AIRMEN ESTATES SUBDIVISION, FIRST ADDITION, **REVISED**

APPLICATION NUMBER 8 DATE May 18, 2017

DETAIL SITE PLAN

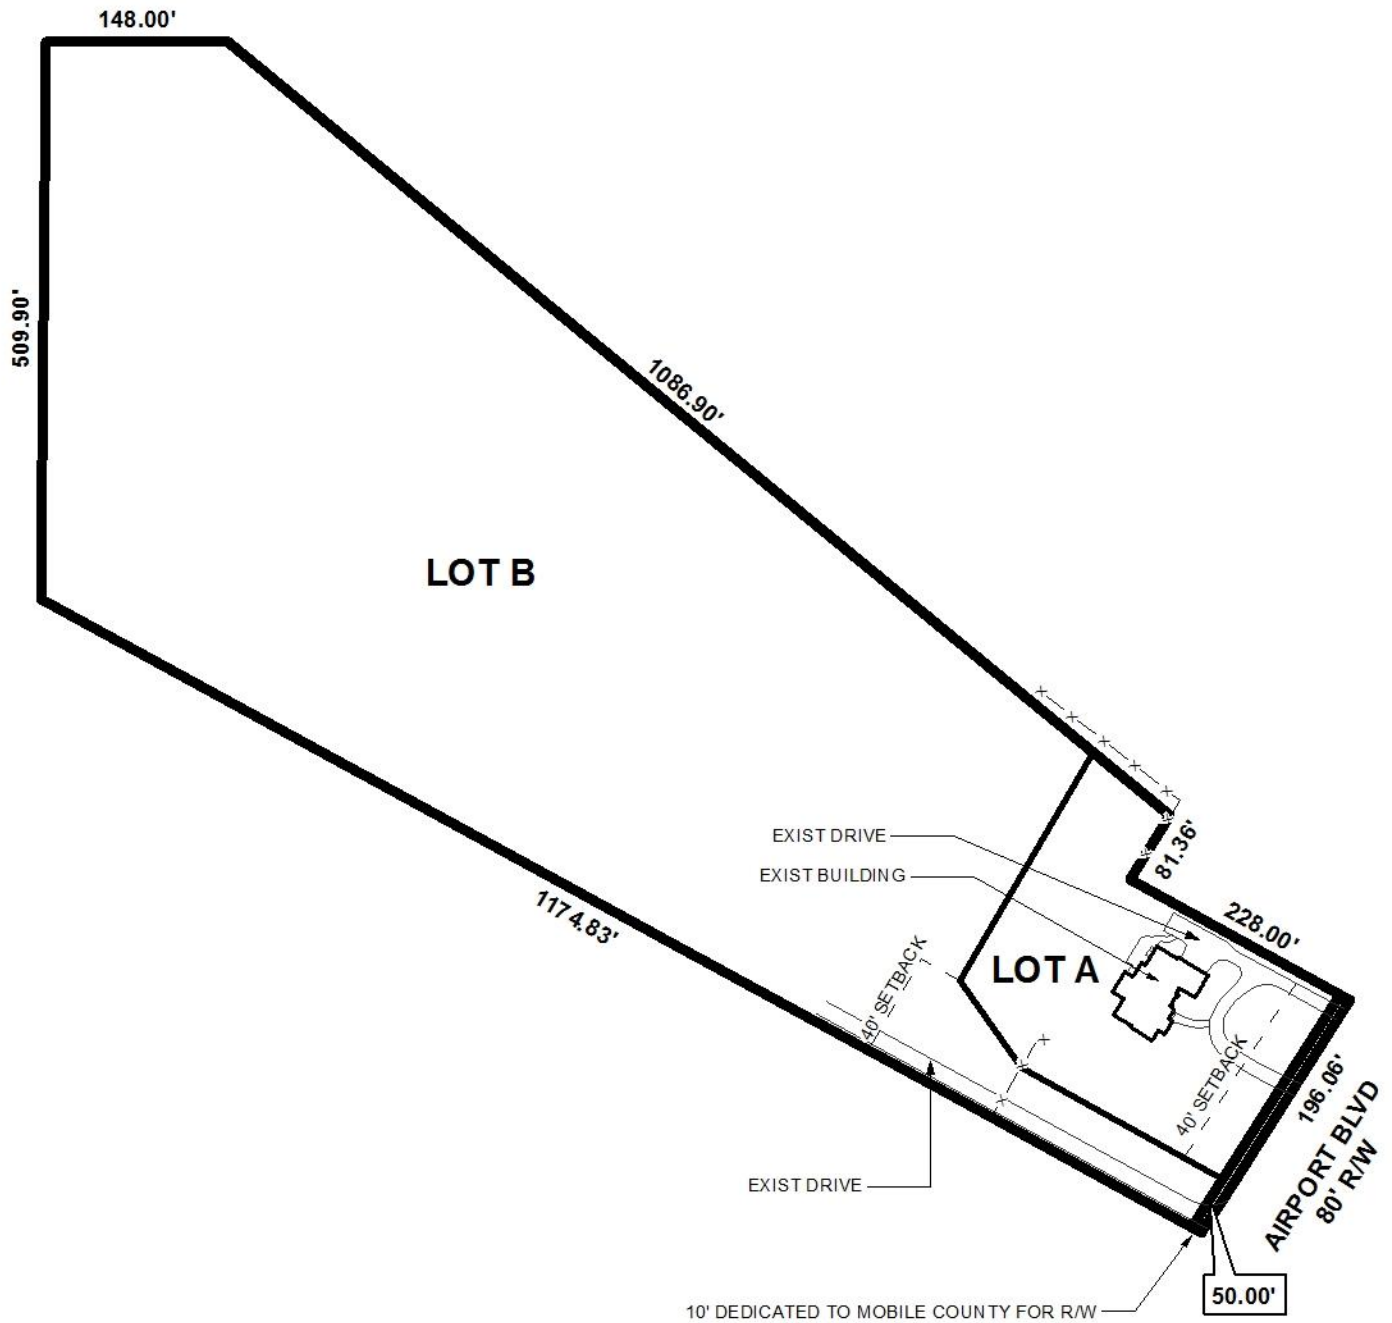
The proposed lots front Airport Boulevard, a major street on the Major Street Plan that requires a 100' right-of-way width. The preliminary plat provides an 80' right-of-way width for Airport Boulevard. The preliminary plat illustrates a 10' strip to be dedicated to provide 50' from the centerline of Airport Boulevard. If approved, the dedication should be retained on the Final Plat. Dedication was required with the 2014 application, however, seven copies of the Final Plat were never provided, so Staff cannot determine if dedication is again required.

The proposed Lot B appears to be used commercially, while the proposed Lot A appears to be used residentially. The preliminary plat provides a note stating "A 10' planting strip or a 6' wood fence will be required in the area where Lot "B" abuts residential property as long as Lot "B" is being used commercially."

The proposed Lot B is a flag lot however, the Planning Commission approved a similar "flag-shaped" configuration for Lot B at its September 4, 2014 meeting, therefore a waiver of Section V.D.I. of the Subdivision Regulations may be appropriate.

A 40' foot minimum building setback line is illustrated on the preliminary plat along the Airport Boulevard for the proposed Lot A and, for the proposed Lot B where the lot is at least 60' wide. If approved, the minimum building setback lines for both lots should be retained on the Final Plat.

As a means of access management, a note should be placed on the Final Plat, if approved, stating that Lot A and Lot B are limited to their existing curb cuts to Airport Boulevard, with changes in the size, design and location of the curb-cuts to be approved by Mobile County Engineering and conform to AASHTO standards.

This site is located in the County; therefore, any lots which are developed commercially and adjoin residentially-developed property must provide a buffer, in compliance with Section V.A.8. of the Subdivision Regulations. A note should be placed on the Final Plat, if approved.

- 1) Retention of dedication sufficient to provide 50' from the centerline for Airport Boulevard or removal of the dedication note if the right-of-way was provided with the 2014 approval;

- 2) Retention of the lot size information in both square and in acres on the Final Plat;
- 3) Retention of at least a 25' minimum building setback line along the Airport Boulevard;

- 4) Placement of a note on the Final Plat stating that Lot 1 and Lot 2 are limited to their existing curb cuts to Airport Boulevard, with changes in the size, design and location of the curb-cuts to be approved by Mobile County Engineering and conform to AASHTO standards;

- 5) Placement of a note on the Final Plat stating that any lots which are developed commercially and adjoin residentially developed property must provide a buffer, in compliance with Section V.A.8. of the Subdivision Regulations;
